Oconee Nuclear Station, Units 1, 2, and 3  
Docket Numbers 50-269, 50-270, 50-287  
Renewed Operating Licenses DPR-38, DPR-47, and DPR-55

**Subject: Response to Requests for Additional Information Concerning Oconee Nuclear Station's Overall Integrated Plan With Regard To Requirements for Spent Fuel Pool Instrumentation**

**Response to NRC RAIs Regarding the  
ONS Overall Integrated Plan for Reliable Spent Fuel Pool Instrumentation**

### FIGURE 1

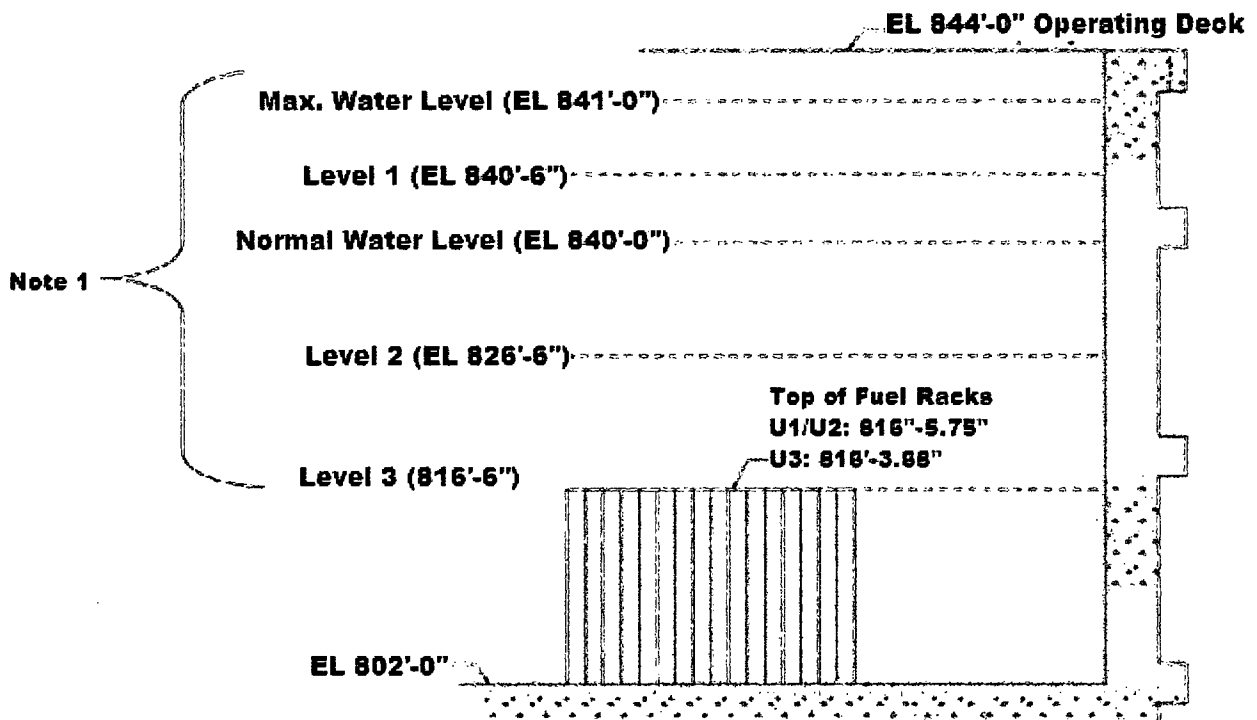
- a) For Level 1, specify how the identified location represents the HIGHER of the two points described in the [Nuclear Energy Institute] NEI 12-02 guidance for this level.
- b) A clearly labeled sketch depicting the elevation view of the proposed typical mounting arrangement for the portions of instrument channel consisting of permanent measurement channel equipment (e.g., fixed level sensors and/or stilling wells, and mounting brackets). Indicate on this sketch the datum values representing Level 1, Level 2, and Level 3 as well as the top of the fuel. Indicate on this sketch the portion of the level sensor measurement range that is sensitive to measurement of the fuel pool level, with respect to the Level 1, Level 2, and Level 3 datum points.

- a) Level 1 as defined in NEI 12-02 is the higher of two points defined by :
  - A - The level at which reliable suction loss occurs due to uncovering of the coolant inlet pipe, weir or vacuum breaker (depending on the design), or
  - B - The level at which the water height, assuming saturated conditions, above the centerline of the cooling pump suction provides the required net positive suction head specified by the pump manufacturer or engineering analysis.

The normal SFP water level is Elevation (El.) 840'-0".

The SFP cooling pump suction piping submergence is lost when water level decreases below El. 836'-0" (Point A).

During normal operation, SFP cooling pumps are automatically tripped at El. 837'-6" to protect against NPSH and vortex concerns. However, as the SFP temperatures increase above normal, including temperatures that approach saturation conditions, the SFP cooling pump flow rates are procedurally controlled to prevent operation with potentially inadequate net positive suction head (NPSH) or vortex conditions based on engineering analysis. Under these high temperature and reduced flow conditions, the limiting level which provides protection against inadequate NPSH or vortex conditions is El. 840'-6", which is 6 inches above the normal SFP water level. Due to the design of the SFP suction piping, pump operation cannot be supported at all during saturation conditions in the pool. Thus, Point B for ONS can only be approximated by the point at which NPSH protection is provided, which varies dependent on SFP conditions. Under normal conditions, Point B relates to El. 837'-6", as provided in the overall integrated plan submitted February 28, 2013. But as SFP temperatures approach saturation, Point B relates to El. 840'-6". Therefore, ONS will consider El. 840'-6" as its "Level 1" datum due to it being higher than Point A and higher than El. 837'-6". Each channel will be capable of indicating any of these levels, as well as the other level datum required by NEI 12-02 (See Answer b below for explanation of the expected range of the level instruments).

- b) The radar level instrument design will locate components in the SFP area such that they remain above the maximum water level in the SFP and the equipment mounts will not require any connections to be made to the pool liner. The mounting brackets for the wave guided assemblies and receiving horns will be secured to the SFP operating deck which is at El. 844'-0". The specific installation locations for the wave guided assemblies and receiving horns has not been finalized and this information is not available within the 28-day

Figure 1 provides the elevations representing Level 1, Level 2 and Level 3, the top of the fuel and the level monitoring range.

Note 1: Final location of equipment is not determined, but the range will meet or exceed elevations defined by the maximum pool level and the top of the fuel racks.
